# HUNTERS RIDGE BUILDING -D

Pasco County Florida  
**REVIEWED FOR CODE COMPLIANCE**  
Approval of these documents constitutes  
authority to proceed with the work but does not  
grant authority to violate, cancel, alter or set  
aside any of the technical codes

**A.E.C.S. 16022 QUAIL & ELK MODELS**

**COVER SHEET BUILDING - D**

QUAIL ELECTRICAL PLAN SALE 3/16" = 1'-0" A.E.C.S. 16022 QUAIL & ELK MODELS

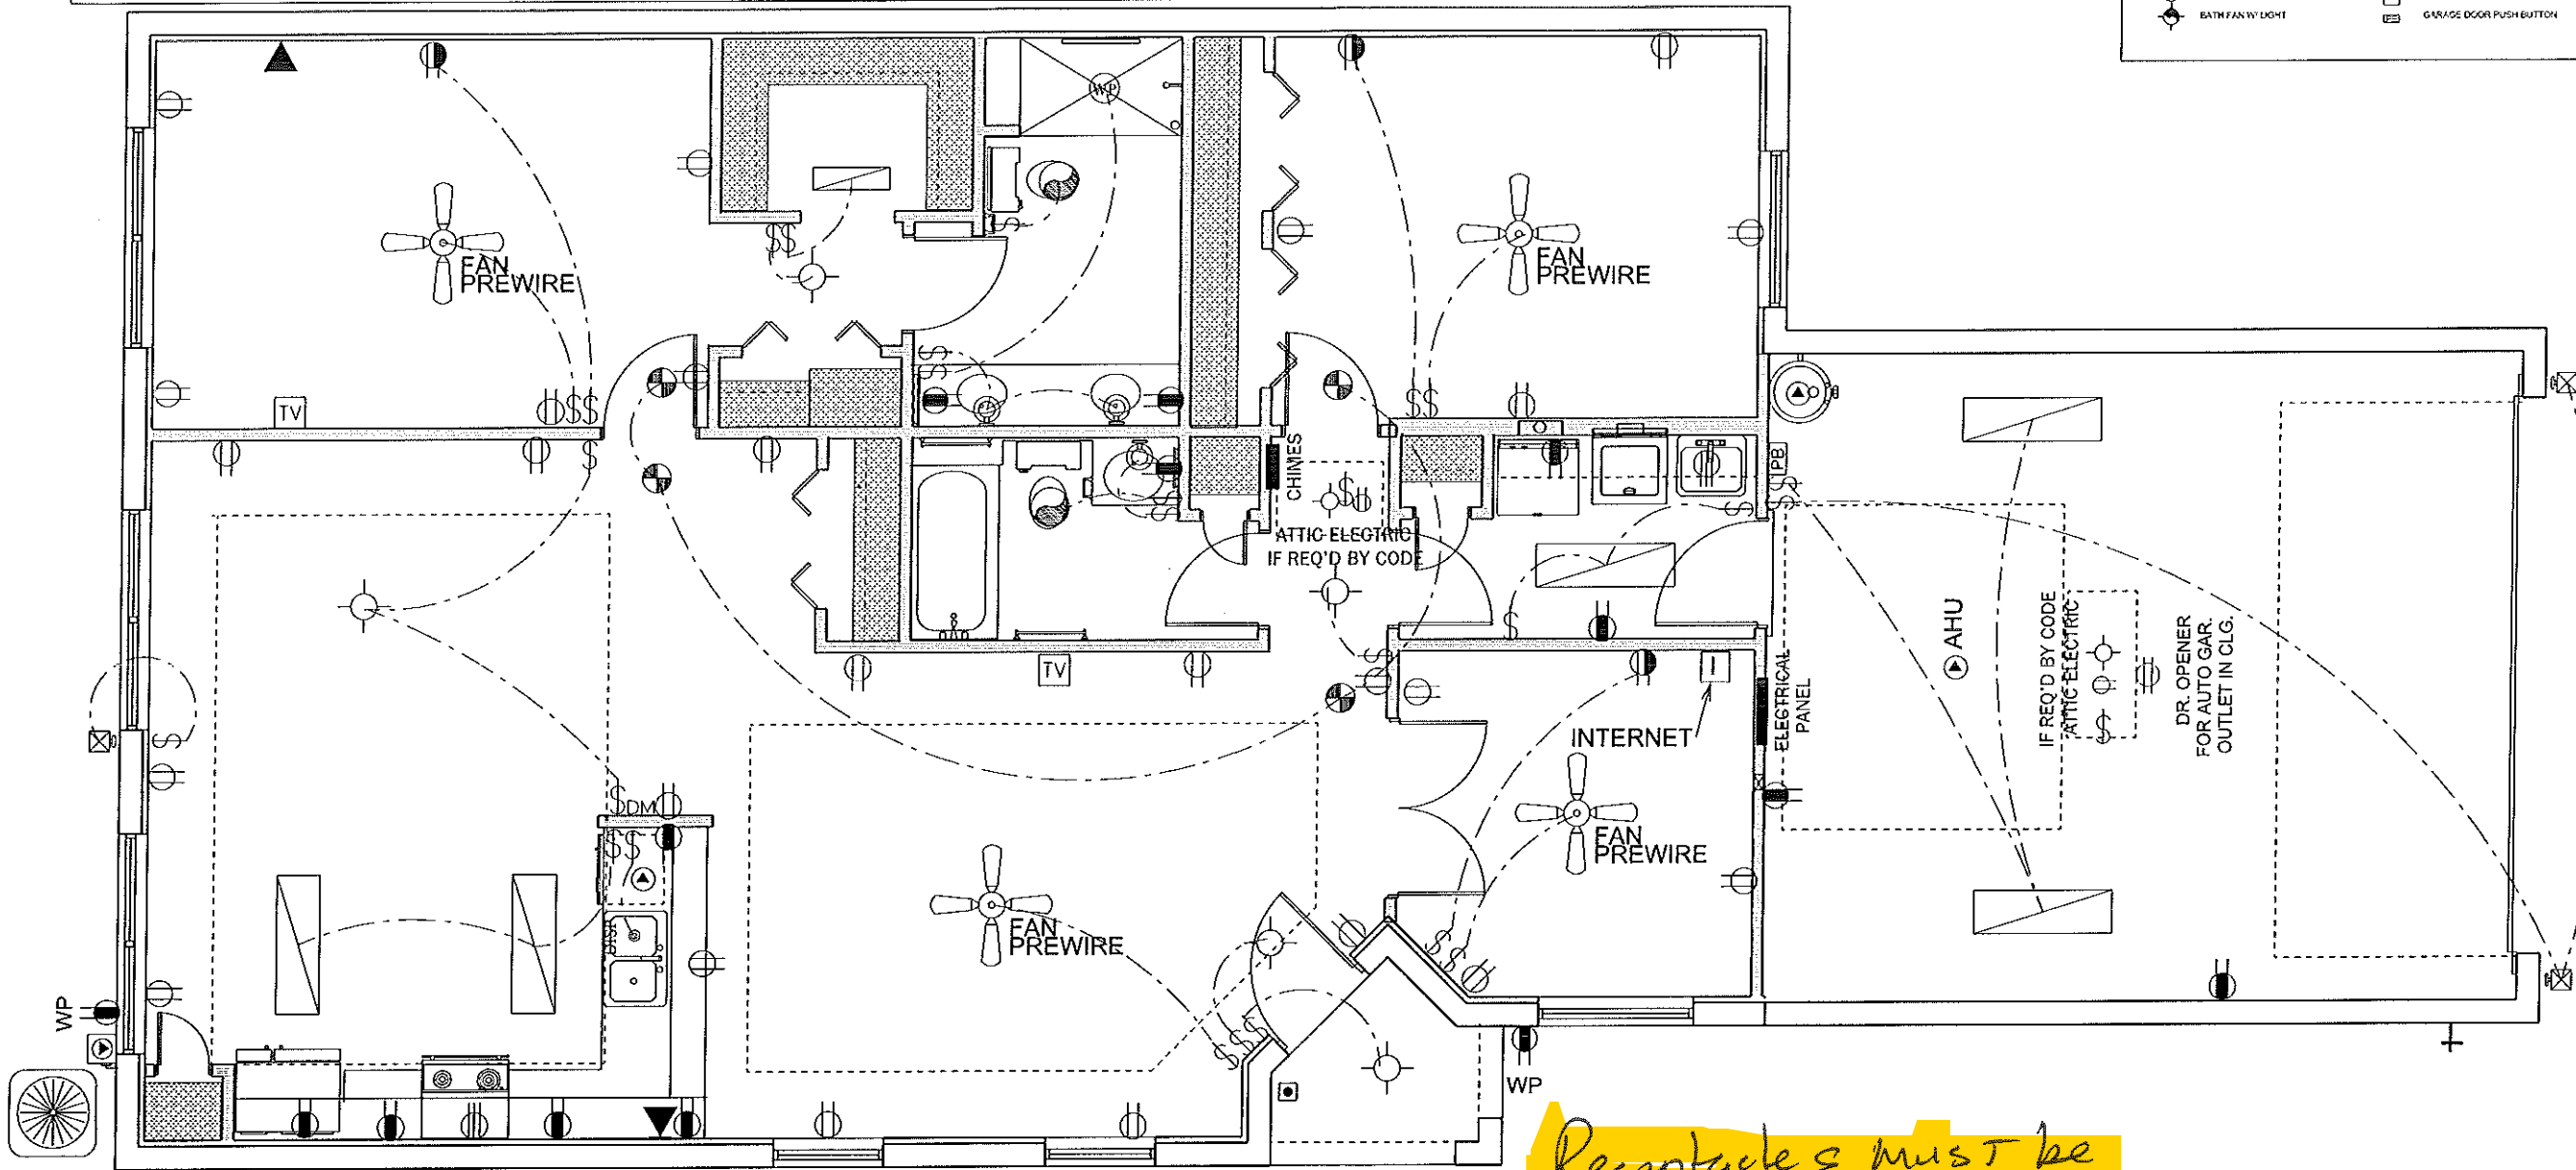
*Receptacles must be spaced to code 210.52*

TYPICAL EXTERIOR FIRE OVERHANG

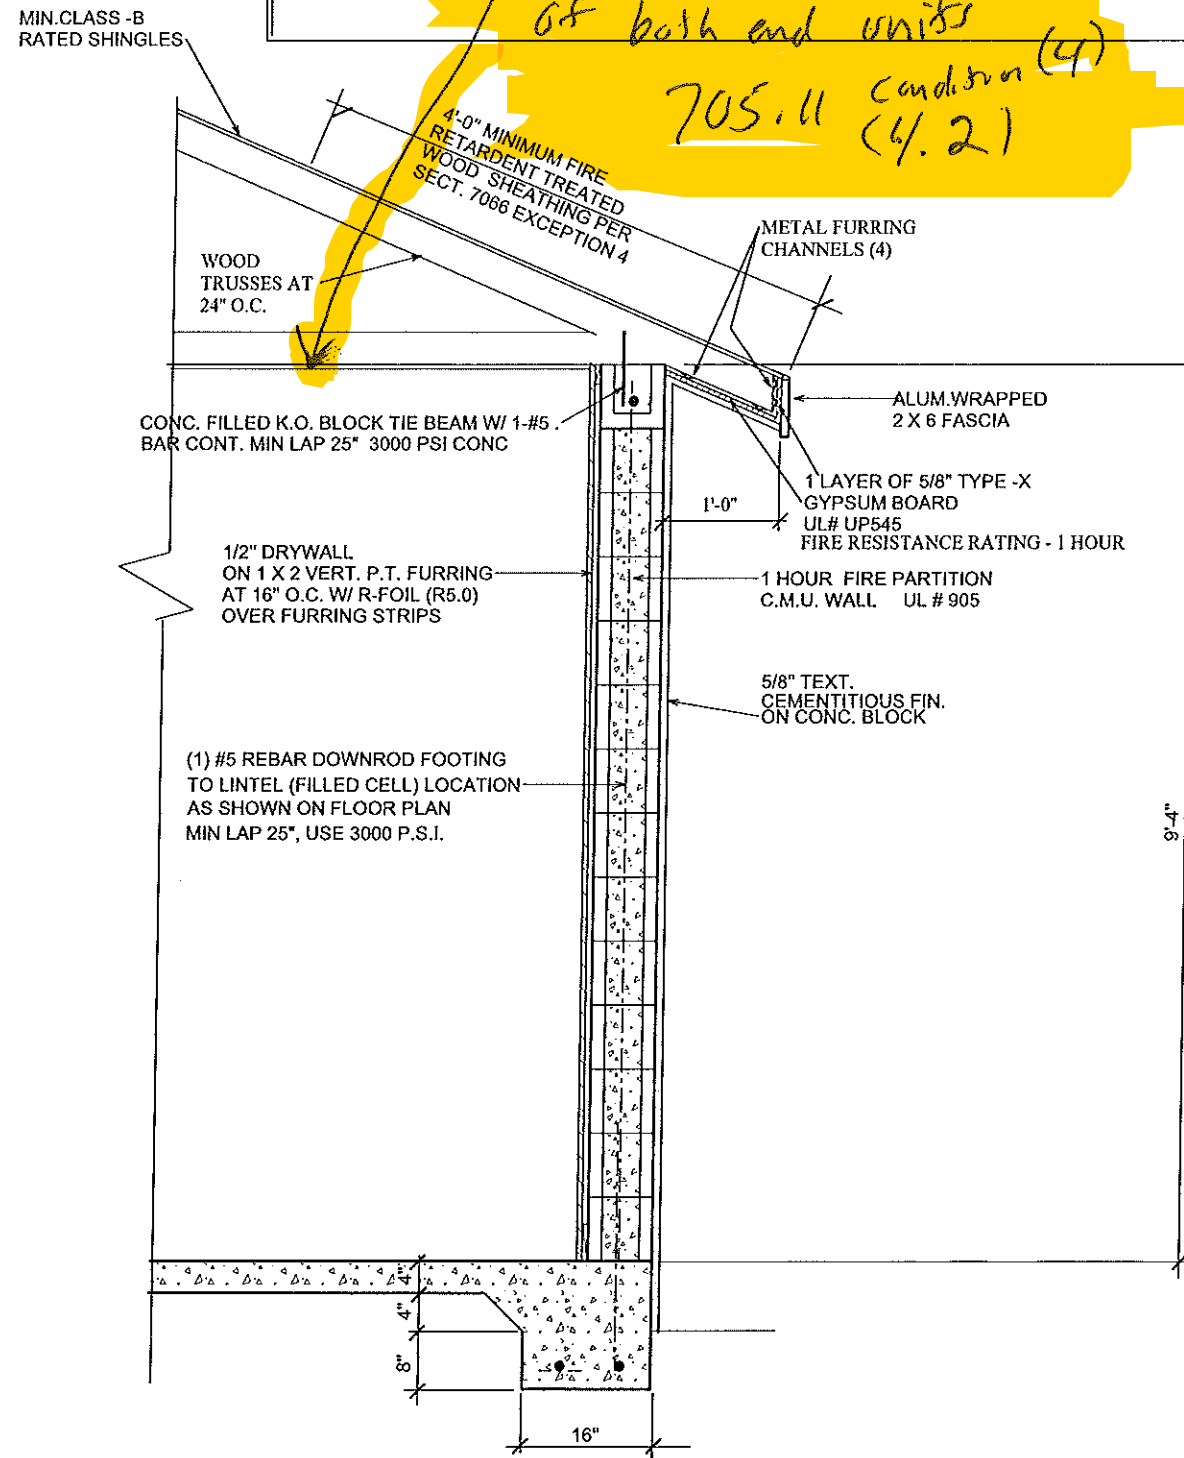
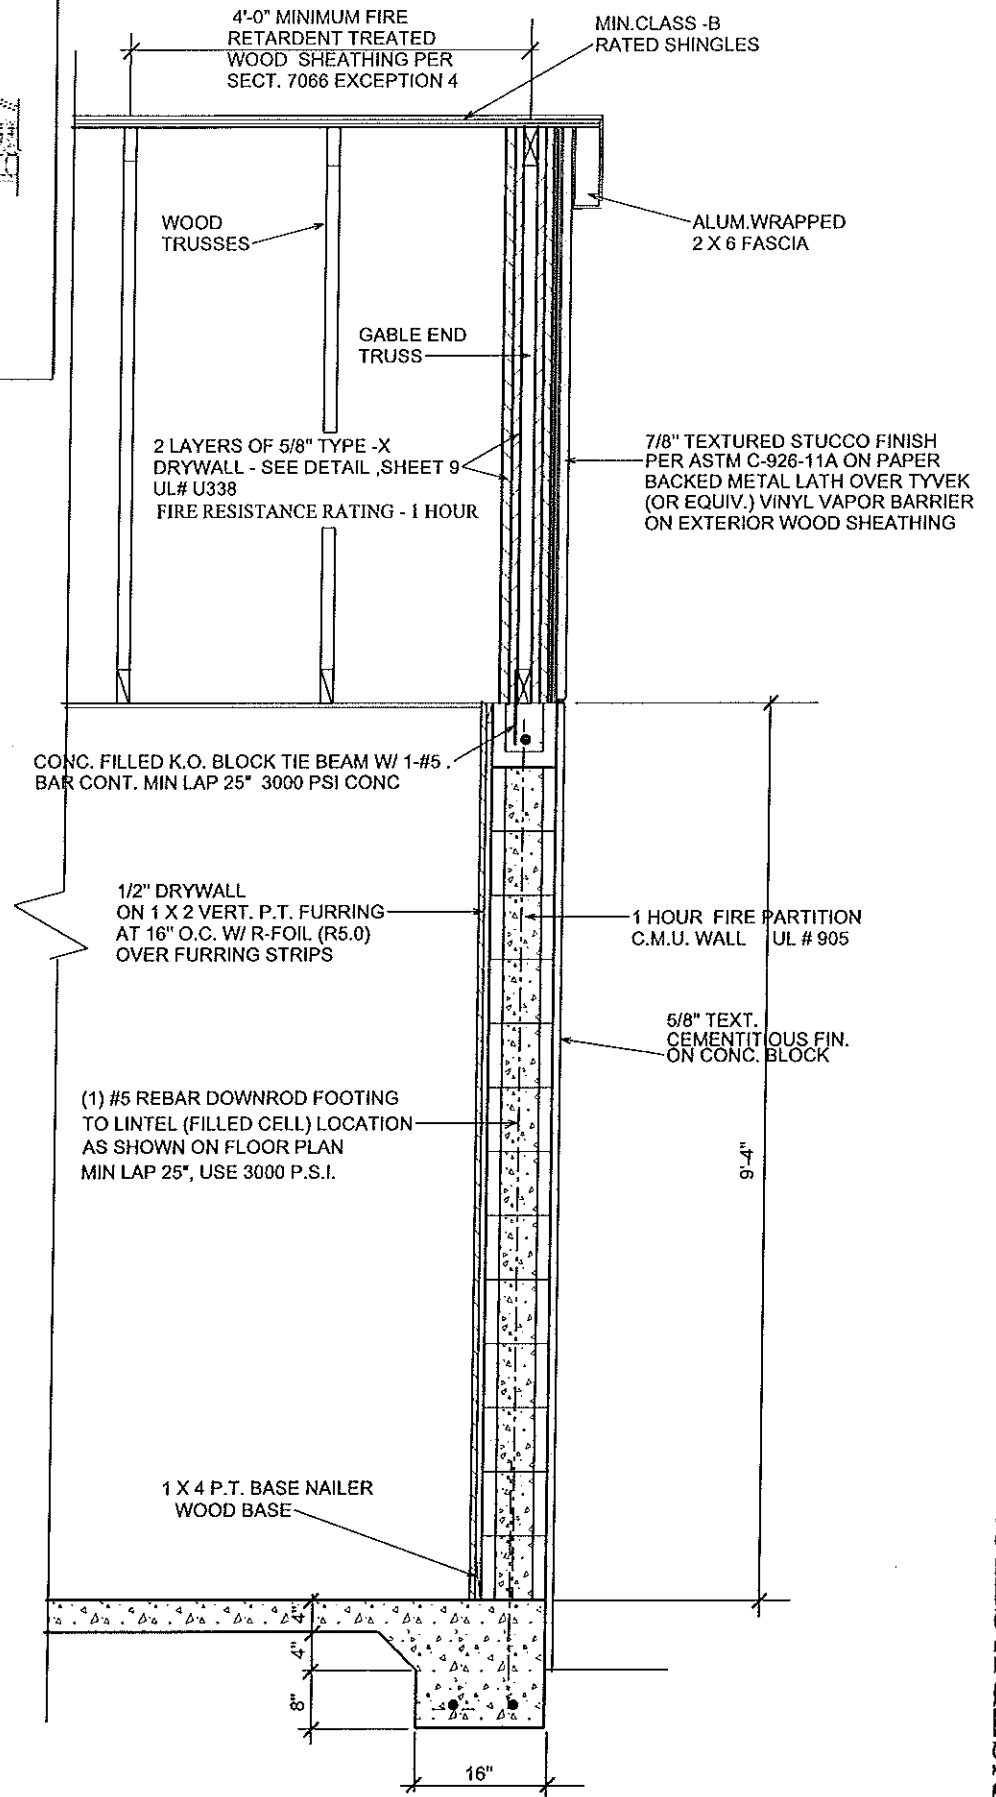
*Need to Rate Ceiling of bath and units*  
**705.11 condition (4) (4.2)**
